The City of Spartanburg Design Review Board

AGENDA

March 5, 2024, at 6:00 P.M.

SUBJECT
DRB-214 Oakland Avenue

251 East Main Street
Spartanburg Design Review Board
2/29/2024

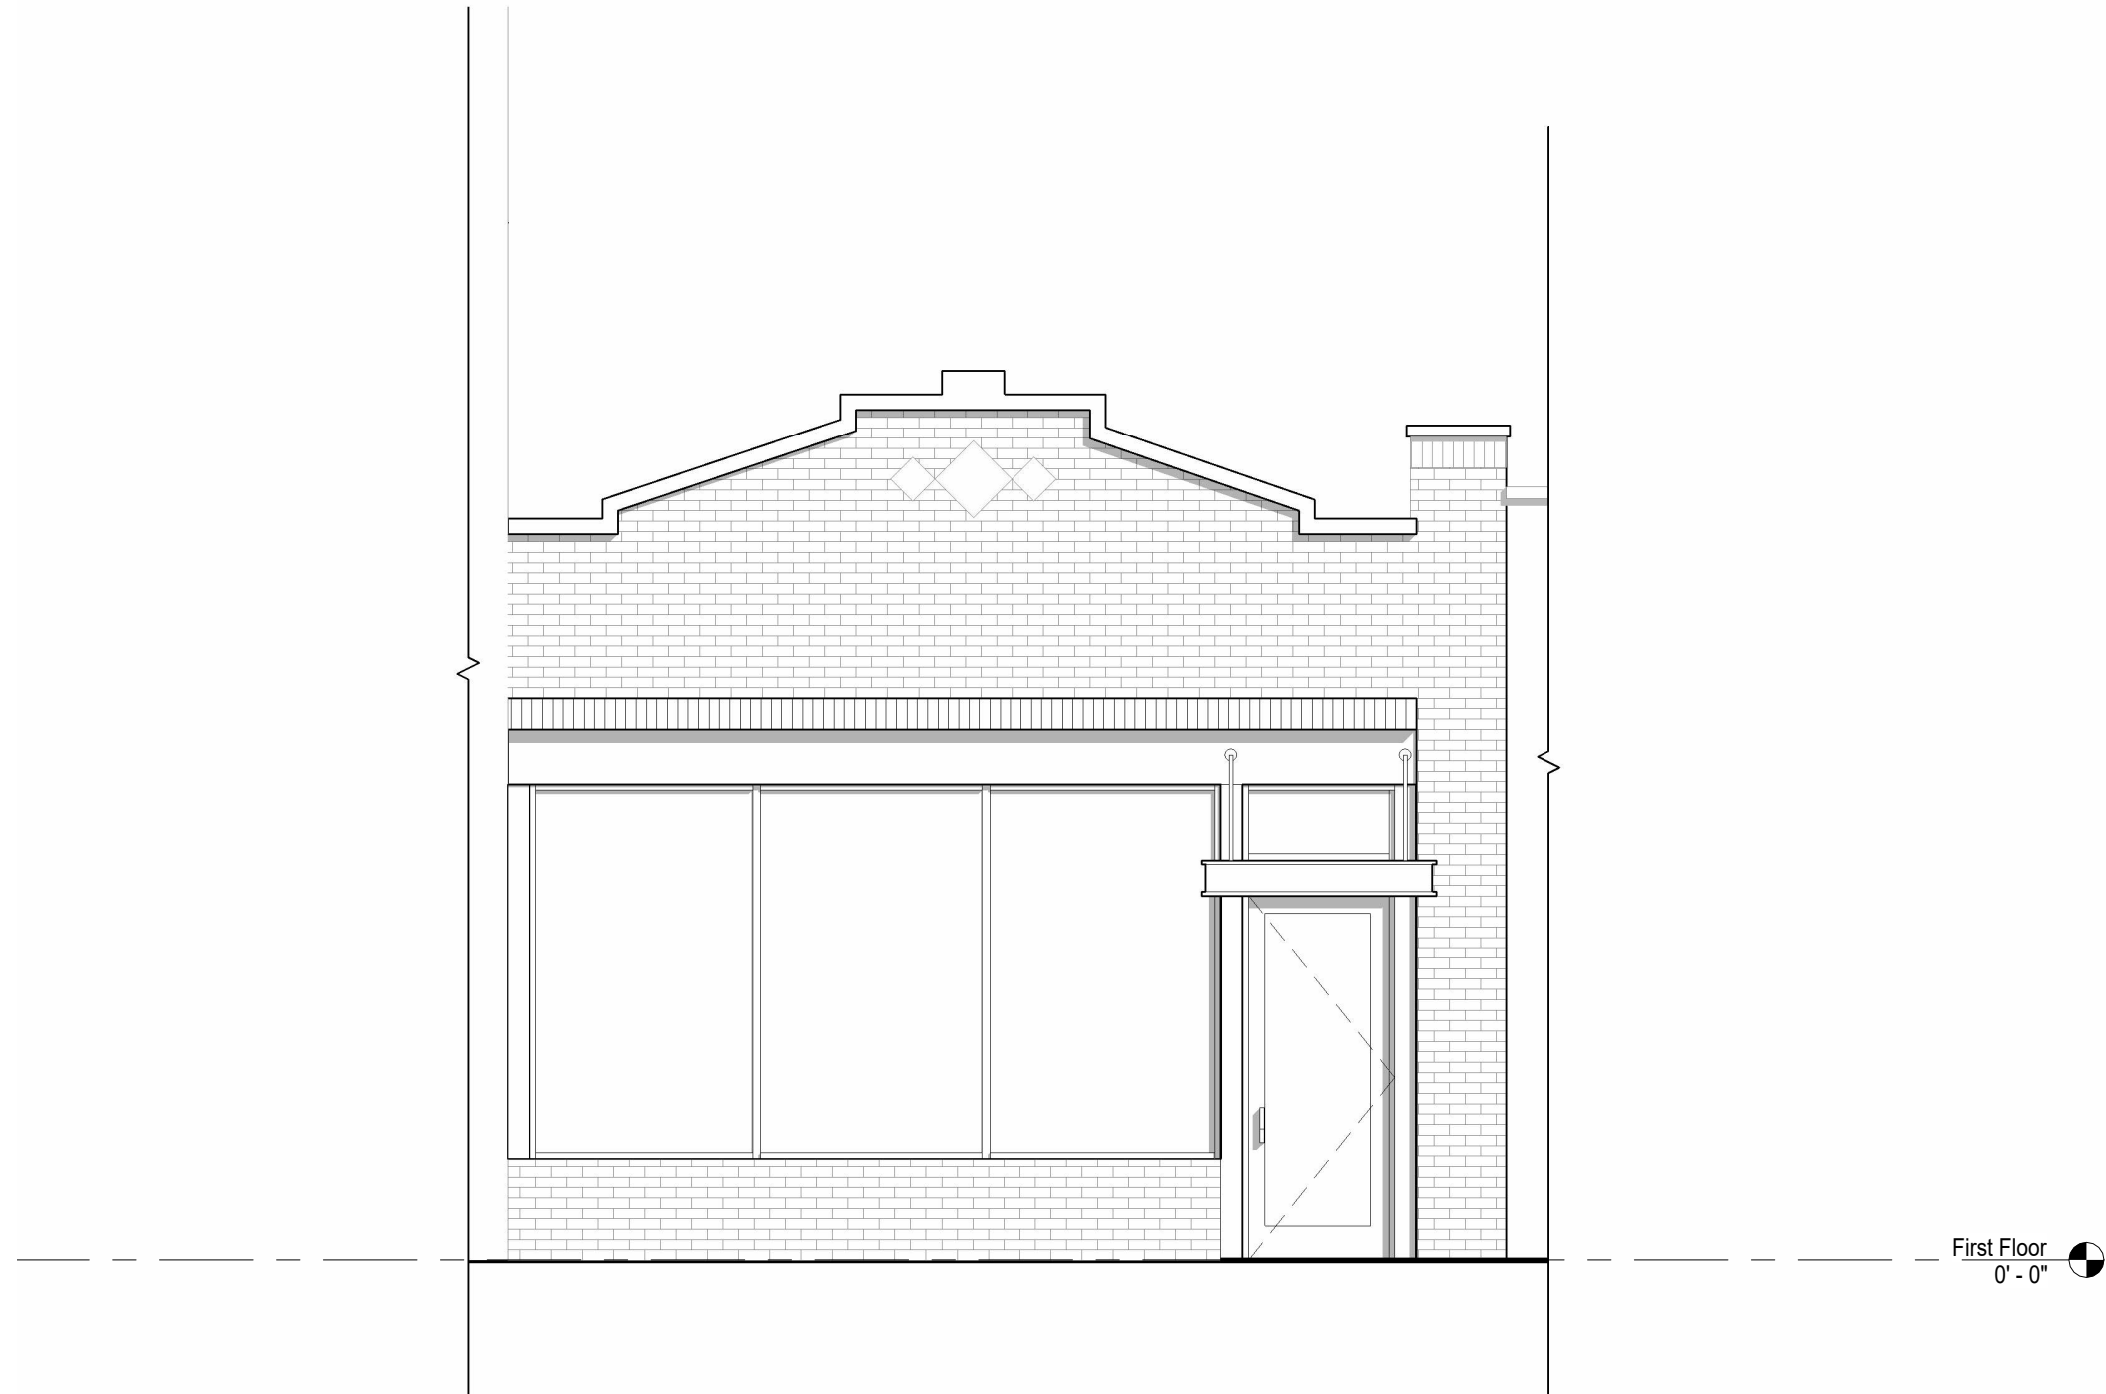
- **Provision of Canopy or Awning:** Along Main Street, the canopies and awnings of buildings provide shelter from sun and rain to pedestrians walking by. It appears that no canopies or awnings have been provided in the renovation of the facades of the neighboring buildings, however, that should not be the precedent. Because this application requires Board approval, we typically recommend the installation of some type of a canopy or awning that is consistent with the other commercial storefronts along Main Street and with the code requirements. In this case, the client has requested an exception to our standards based on the following request:

- *There is a desire to maximize the natural light into the building along the frontage and the placement of a canopy or awning across the full frontage would be challenging for this building as it is north facing, short in height and relatively narrow. We believe that the entrance canopy is of sufficient width to ensure pedestrian comfort while providing relief from the elements for both building tenants and passersby.*

We recommend final approval of the application including the granting of an exception to minimize the required canopy to span only the entry.

OAKLAND AVENUE TOWNHOMES

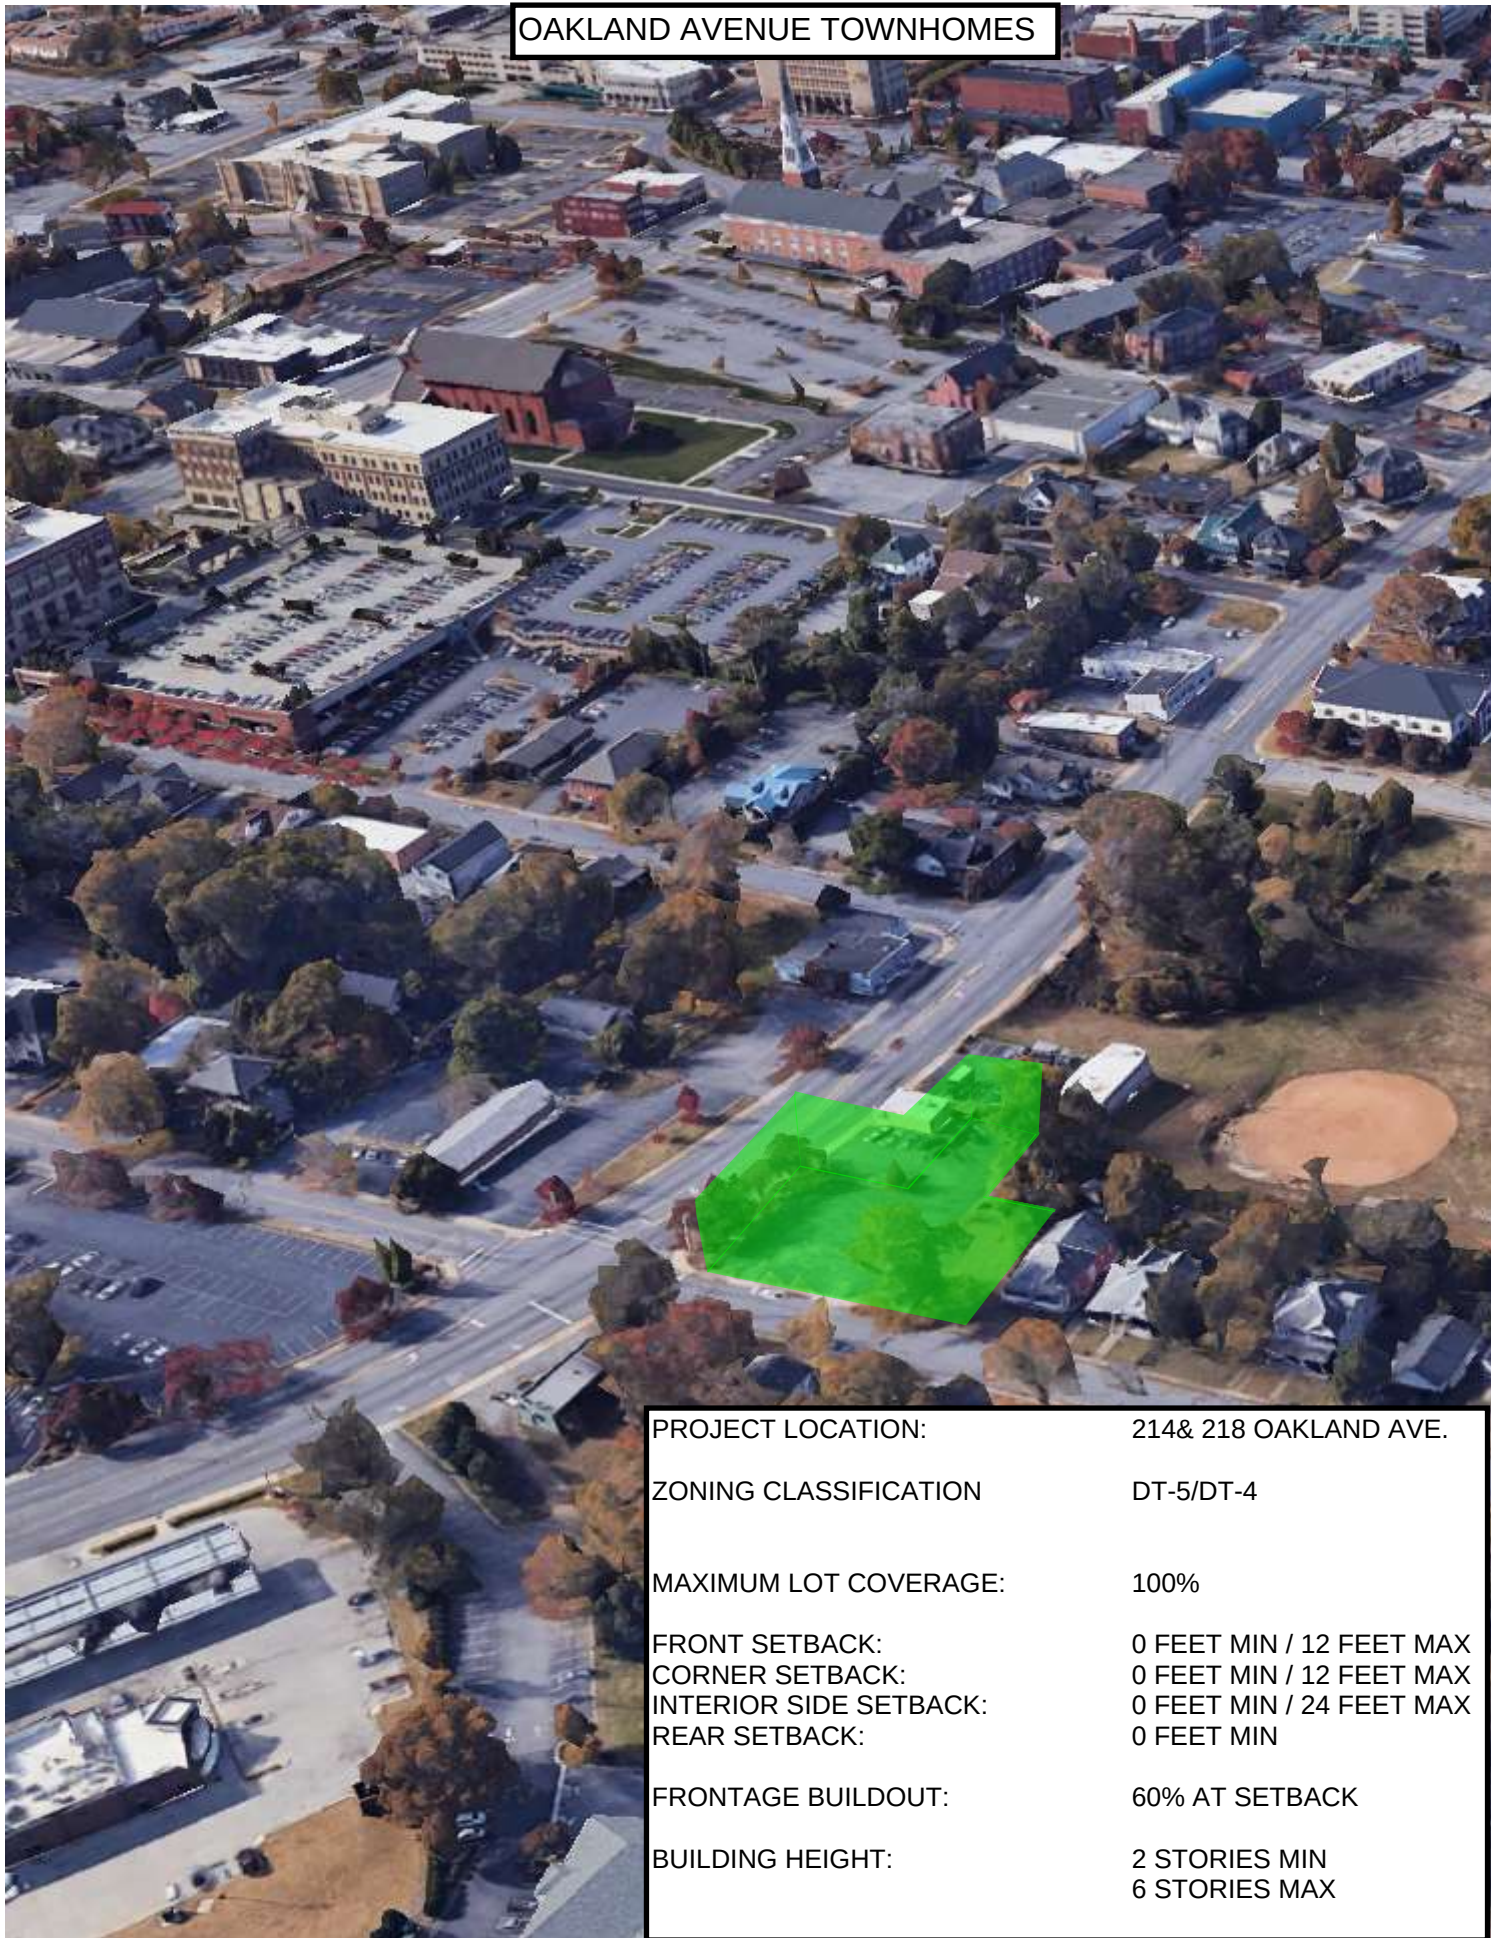
- **Elevation Details:** The submitted elevation drawings lack some of the usual detail required for final approval. We recommend approval subject to inclusion of the following notes on the plan:

- **Landscape Plan:** Please provide landscape plan detail for the side and rear of Units 3-6 (e.g., vegetation, ground cover, fences, retaining walls)

We recommend final approval conditioned on the modifications noted above.

Site Plan

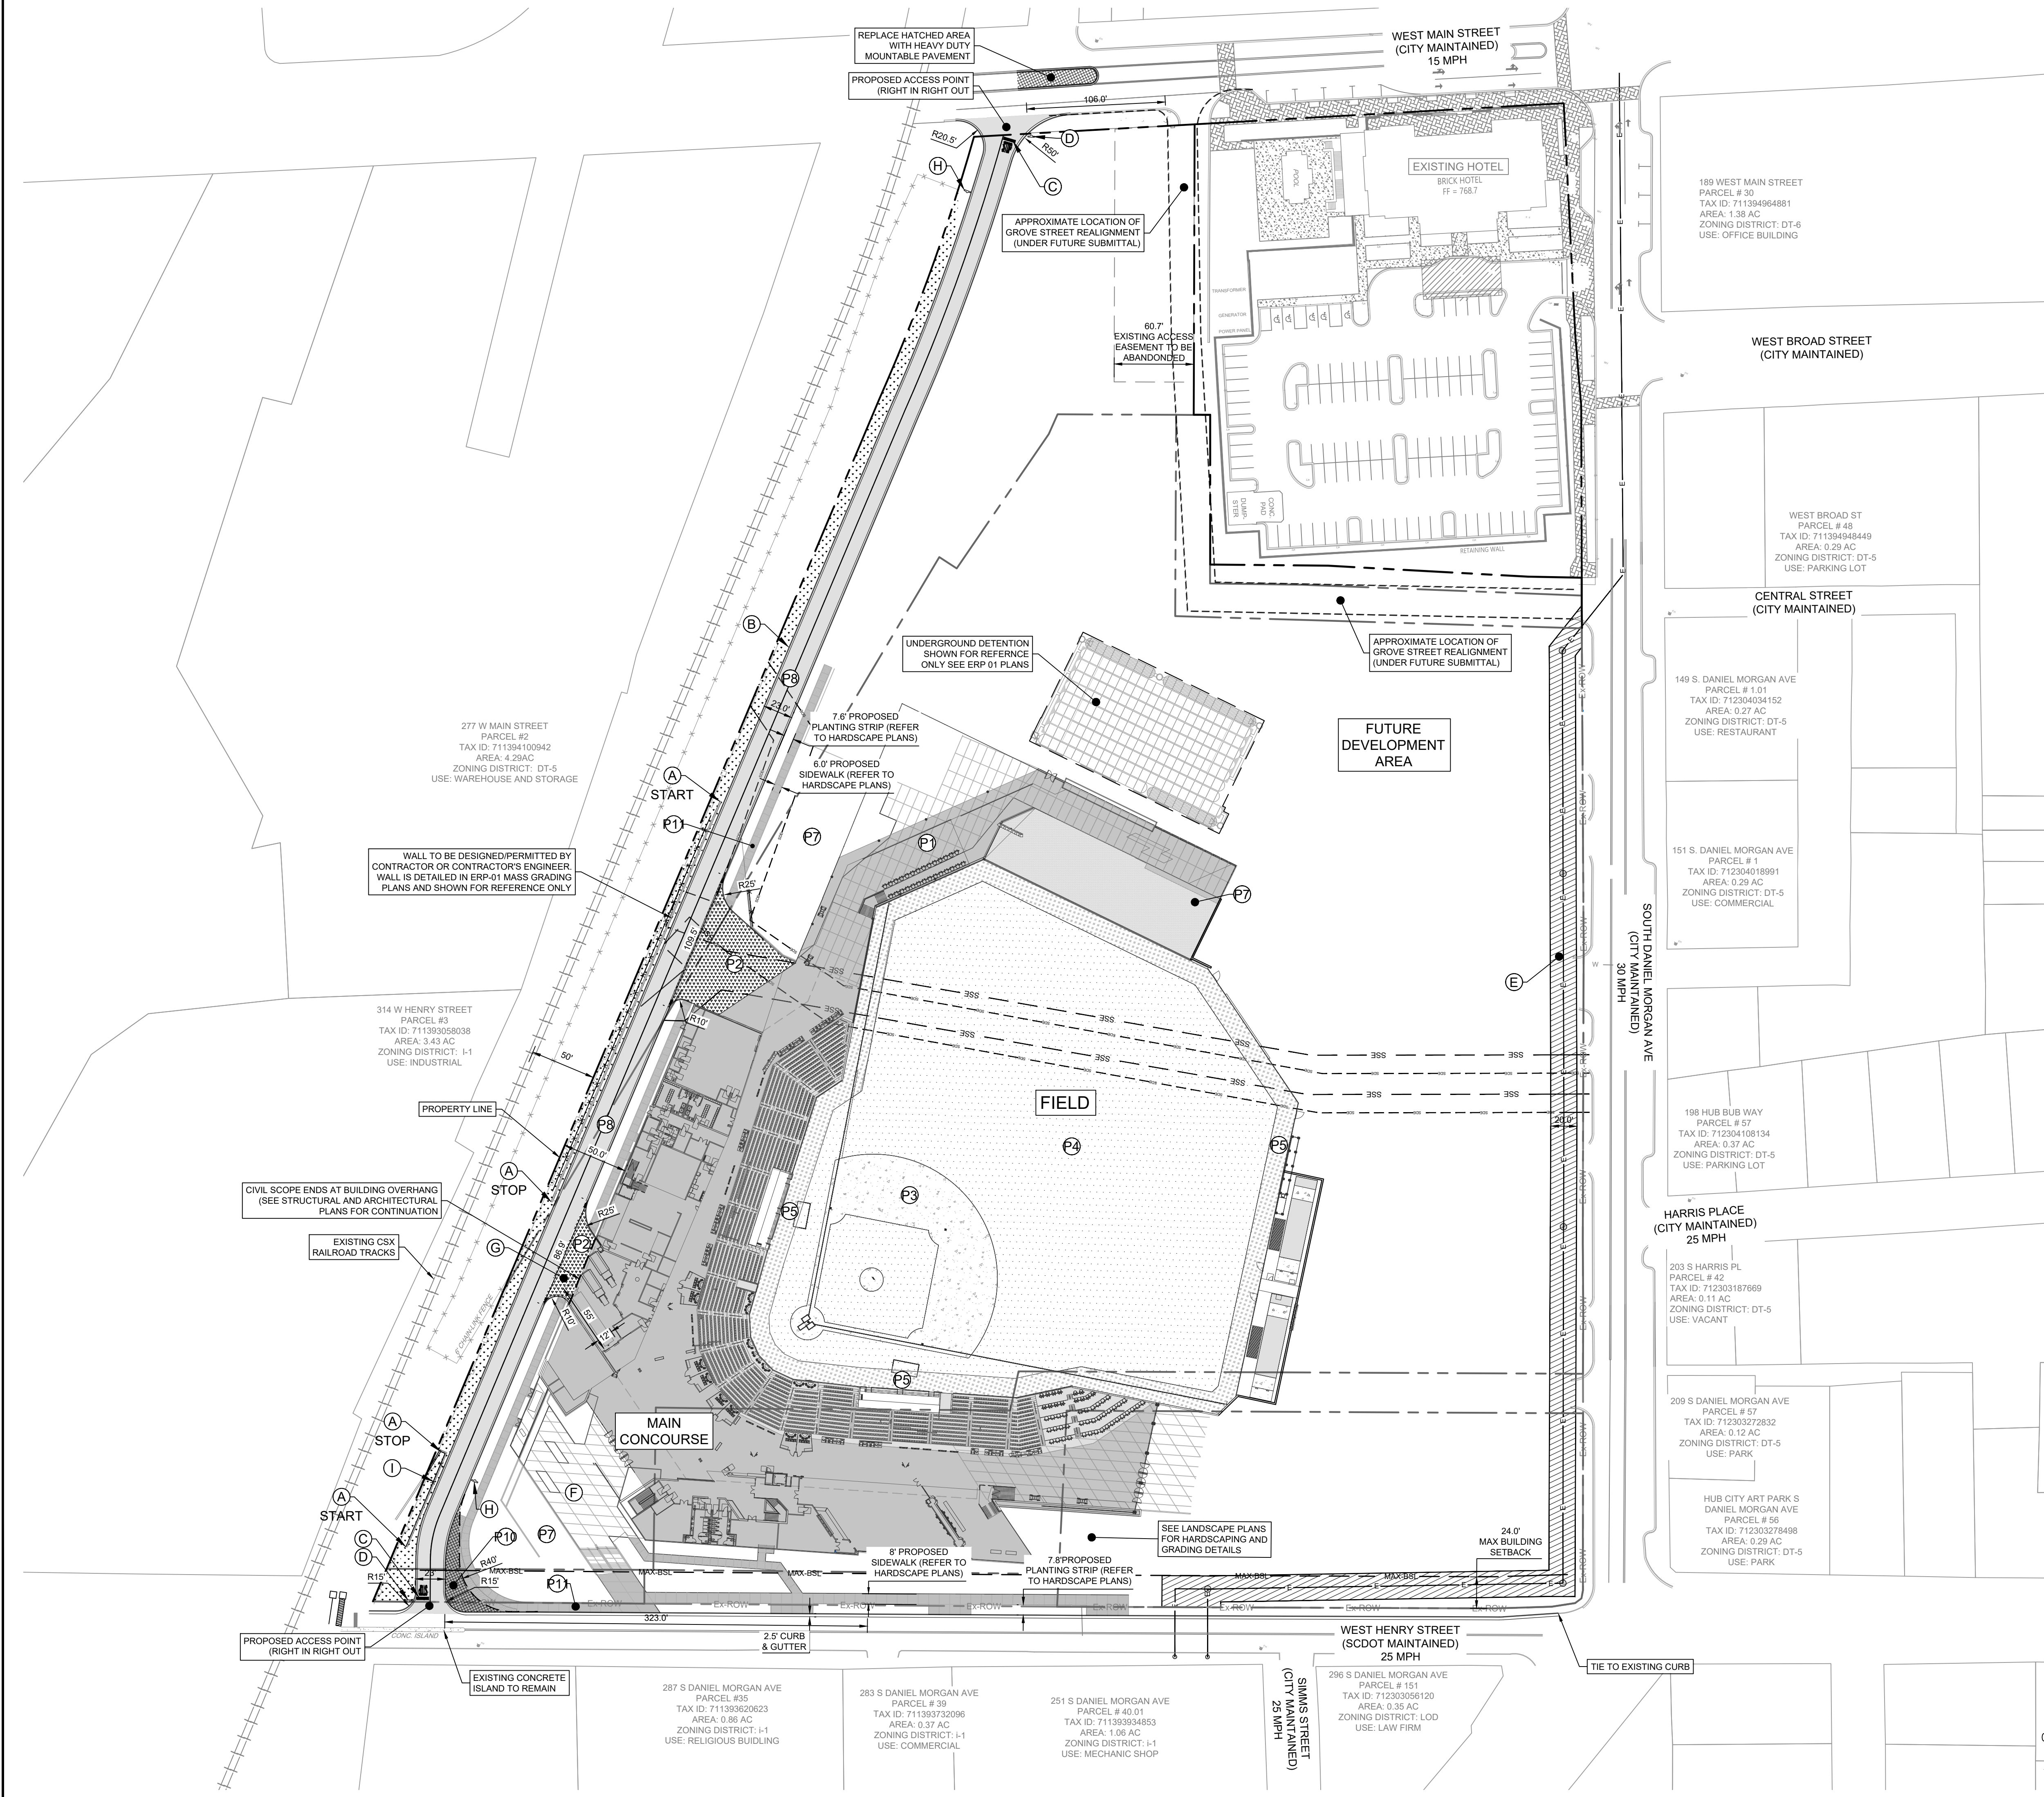
- **Substandard Streetscape along Daniel Morgan Avenue Street:** The current plans do not show an upgraded streetscape along Daniel Morgan Avenue. Given the expectation of heavy foot traffic from the ballpark to Morgan Square, this street should be upgraded at the same time. The streetscape should be consistent with the streetscape plan for the renovated Morgan Square.

- **Future Development Along Daniel Morgan:** As noted in the plans, the area in between the ballpark is slated for future development. It is presumed that this future development will be placed between the stadium and Daniel Morgan Avenue, effectively screening that side of the stadium. The DRB may want to consider an interim measure such as supplemental landscaping along that frontage in case those buildings are not delivered in the near term – next five years.
- **Brick Detail on Upper Story:** The inlaid brick pattern on the three panels noted below seems to conflict with the sign. We recommend eliminating the detail for these three sections for a clean sign panel. Additionally, we recommend converting the current square in each remaining panel to two vertical rectangles that more closely mimic the window patterns at the main entry from Henry Street.

- The improvement of the streetscape along Daniel Morgan Avenue (this needs to be shown on the final plans and may be noted as "by the city" if approved by the City Manager
- The consideration of supplemental landscape as a temporary screening element on the Daniel Morgan Avenue frontage.
- The adjustment of the brick details on the upper story to more closely mimic the window patterns near the main entrance.
